Consultation on Window 3 Projects

I am writing to provide GridLink's response to Ofgem's consultation on the "Initial Project Assessment ("IPA") of the Third Cap and Floor Window for Electricity Interconnectors", published on 1 March 2024.

GridLink is developing a 1,250MW interconnector between the UK and France. Whilst GridLink is a Window 2 project and not a Window 3 project, and thus is not one of the projects being consulted on, we believe there are certain key issues which should be highlighted and addressed, and we are therefore responding to the consultation. This response is not confidential.

Figure 1: France Installed Generation Capacity - FES 2022 vs TYNDP 2022

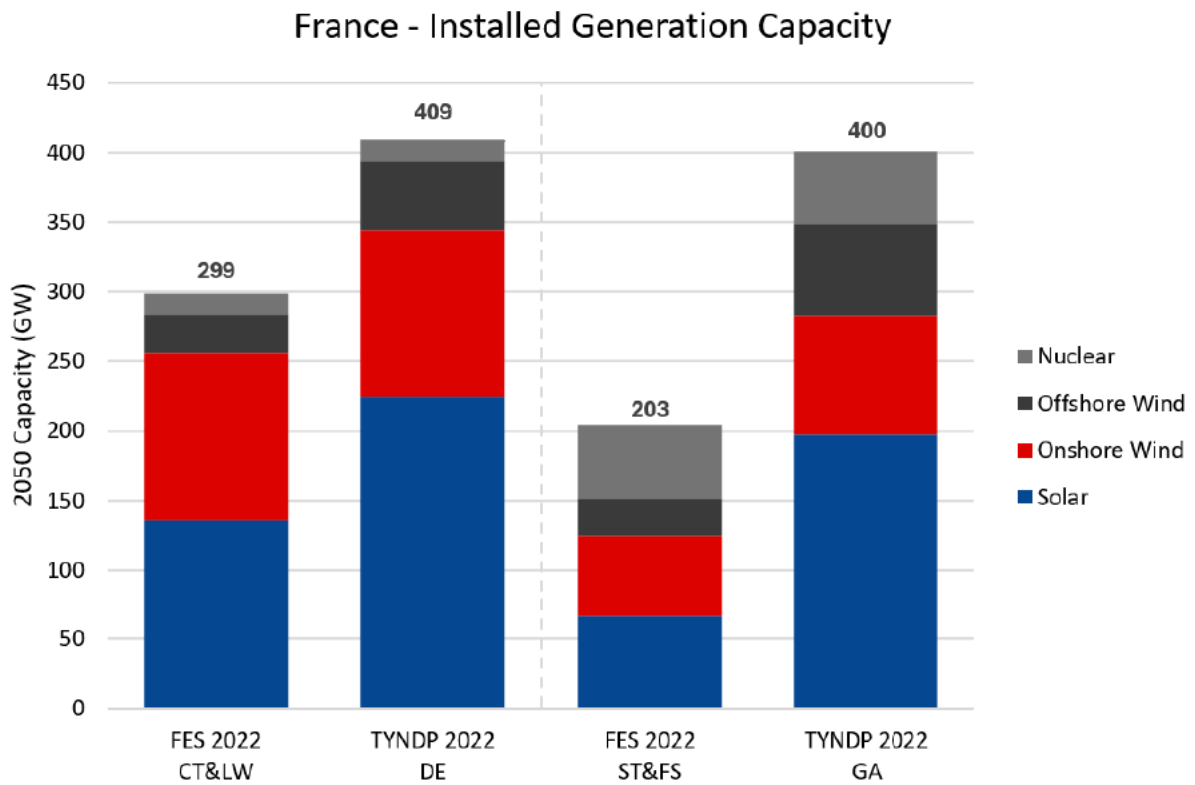
- 4.4. **GridLink’s observation:** Figure 1 below compares installed capacity used in NGENSO’s forecast (FES 2022) to those set out in the TYNDP 2022 for France. It can be seen that they are materially different, with the build out of onshore wind, offshore wind and solar being approximately half NGENSO’s forecasts than in the TYNDP 2022. The effect of this is that French electricity is relatively more expensive than electricity in GB (because GB has a higher penetration of renewables) and consequently GB exports electricity most of the time.

- 4.5. The report does not explain why NGESO forecasts for renewable build out are materially less than the forecasts contained in the TYNDP. We would suggest that if NGESO used the TYNDP forecasts, the congestion charges for interconnectors would be significantly lower than is currently being estimated, because of lower exports and more balanced two-way flows.
- 4.6. We propose that NGESO is in the best position to prepare forecasts for the GB (i.e. the FES scenarios), but that European Network of Transmission System Operators for Electricity (“ENTSO-E”) is in the best position to prepare forecasts for European countries. We recommend that NGESO use the ENTSO-E TYNDP forecasts for European countries.
- 4.7. We note that the TYNDP forecasts are required to meet 2030 and 2050 climate objectives. It is not clear whether NGESO’s forecasts for Europe meet these objectives.

- 5.5. The inability to adequately reconcile between the Arup and NGESO models reduces confidence in the constraint cost calculations and their respective results. We request that Ofgem reappraise the inputs into the NGESO model and run a sensitivity analysis based on TYNDP 2022 to provide an alternative outcome based on a set of assumptions accepted across Europe and which Member State regulators will be required to use.
